## CALUC Meeting Report: September 27th, 2018

Address: 931 McClure

SUBJECT: RE-ZONING OF 931 MCCLURE STREET, VICTORIA BC

SUBJECT: RE-ZONING OF 931 MCCLURE STREET VICTORIA, BC

Figure 1

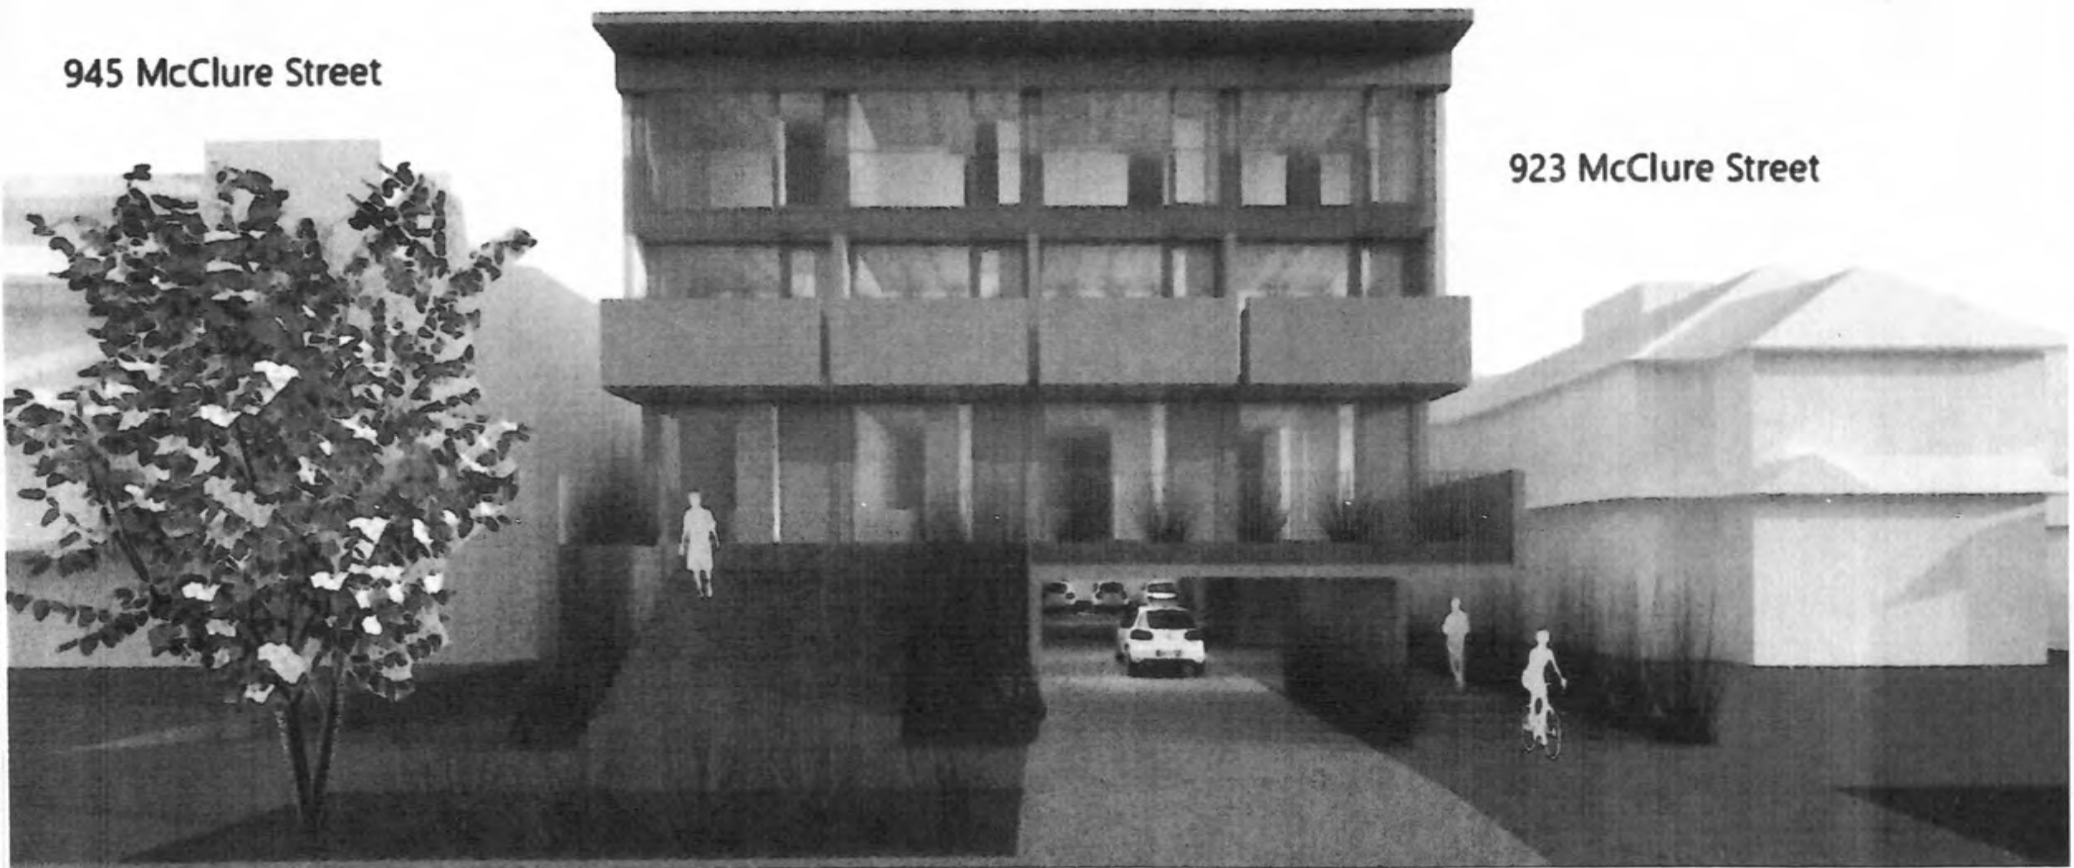
Attached are pictures from the first presentation that was given by Luke Mari, Director of Development of Purdey Group. Figures 1 and 2 show front elevations of the 8 townhouses (4 in front and 4 in the back). Figures 3 and 4 show side elevations from the east and west. The dotted lines represent the outlines of our building at 945 McClure, to the east of 931 McClure; and of the townhouses at 923 McClure, to the west of 931 McClure.

1. Proposed development is too massive for the site.

The proposed design is too big and dense for the existing site. It presents itself as two buildings sitting on top of a common surface parking lot, for a single massive four story "block".

The proposed design provides no setback from the front property line, as required in the OCP.

The front stairs would come right to the public sidewalk. This would not be compatible with existing buildings on the street.

Figure 3

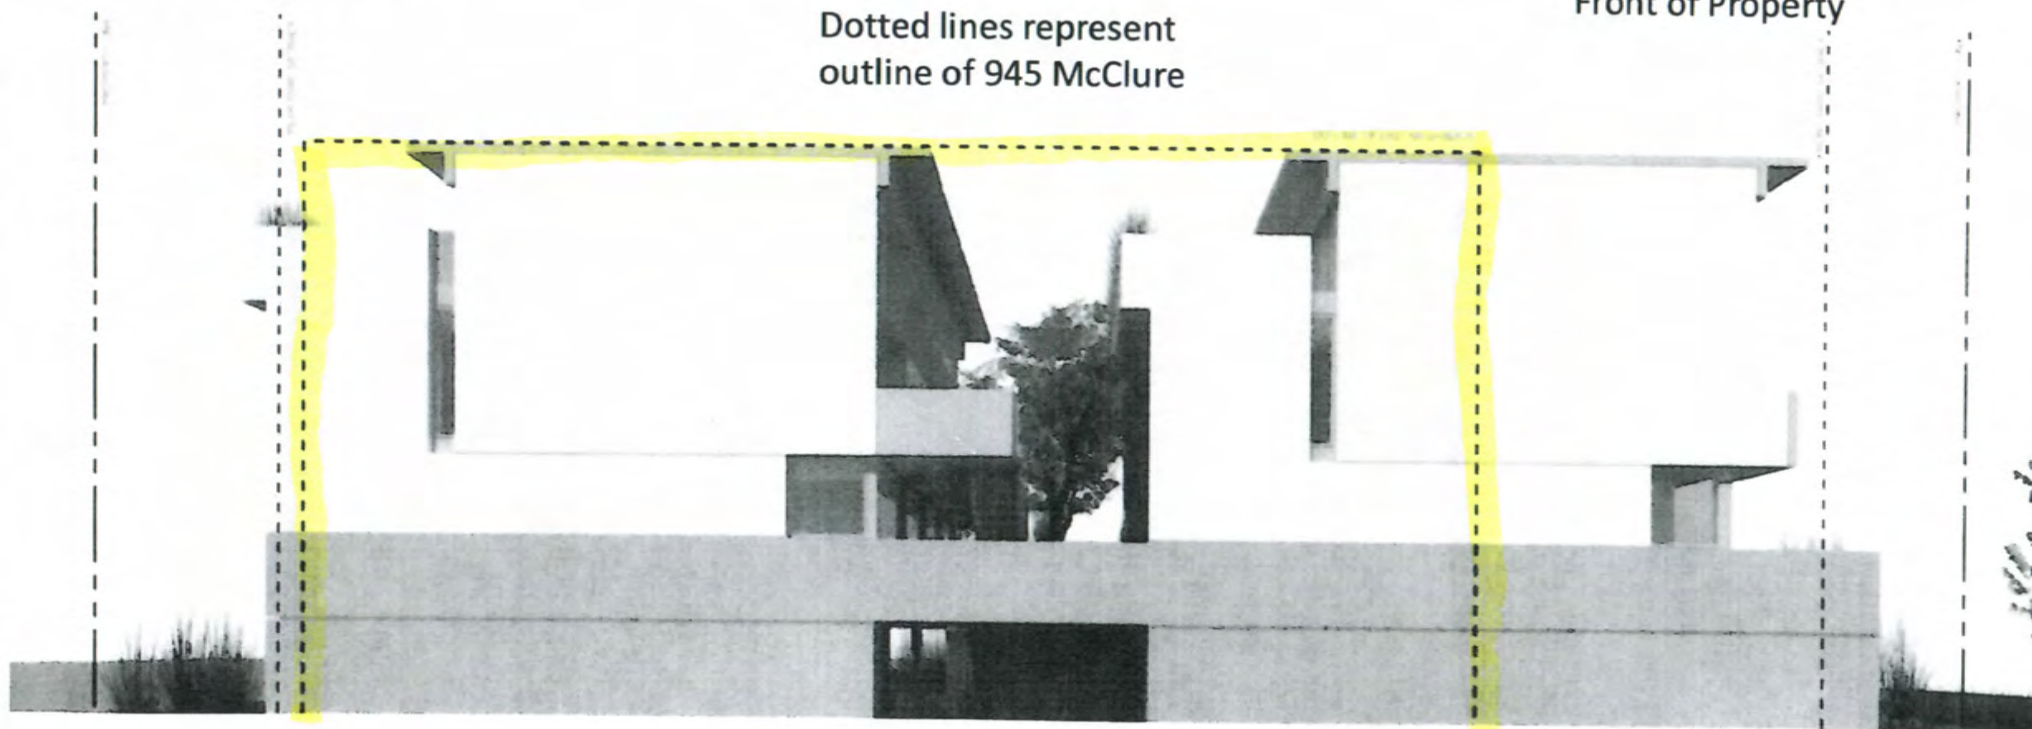
The proposed structure would extend to the very edge of the property line on both sides. On each side, it would present a blank wall, four stories in height, tight against the property line, and extending beyond the facing walls of the buildings on both east and west sides of it.

Our building at 945 McClure Street was not designed to face a blank wall on either side, especially one right at the property line. Our west facing wall contains 8 units on 4 levels. Each unit has 7 windows in this wall, located in 3 separate rooms. All 56 windows would face a massive blank wall that is only feet away.

Sunlight would be eliminated, and daylight significantly reduced, in all 8 units on the west side of our building, by the height, extent and placement of the east wall of the proposed building.

The 56 windows in our west wall bathe their rooms in sunshine from mid-day until dusk. The proposed massive wall just outside each of them would effectively block most sunlight from reaching these windows, especially on the lower floors.

Figure 4

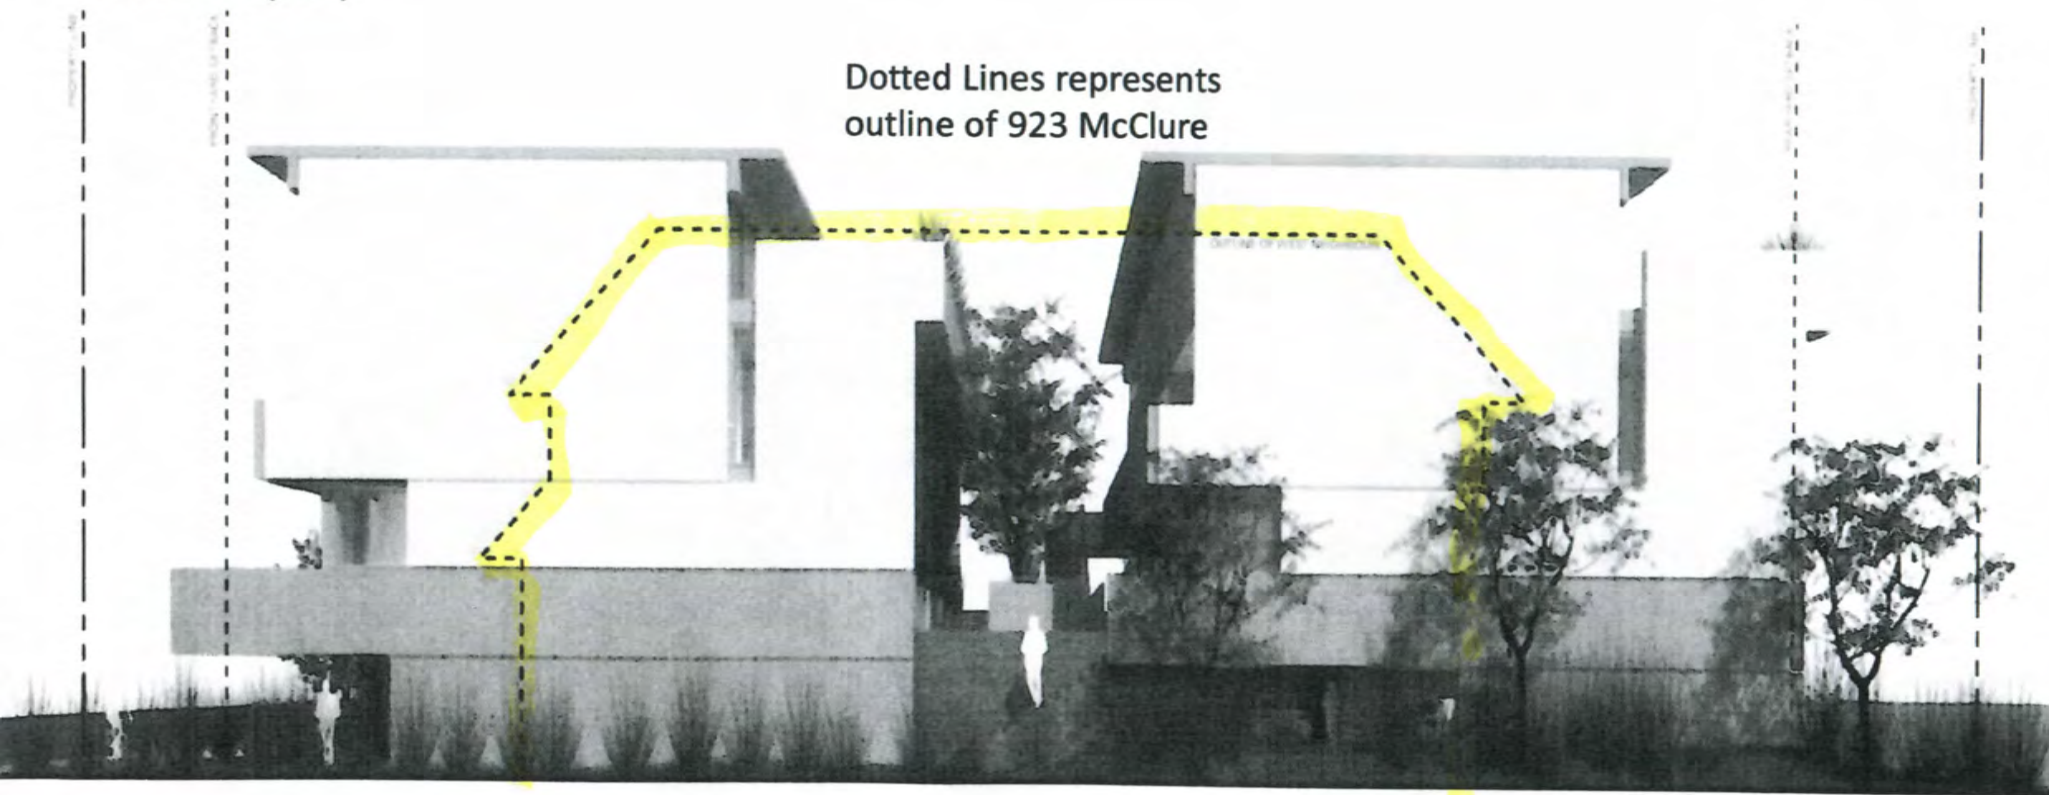
The townhouses at 923 McClure were similarly not designed to face a blank wall right on the property line. They have entry doors, a porch, and windows on two levels in their east facing wall.
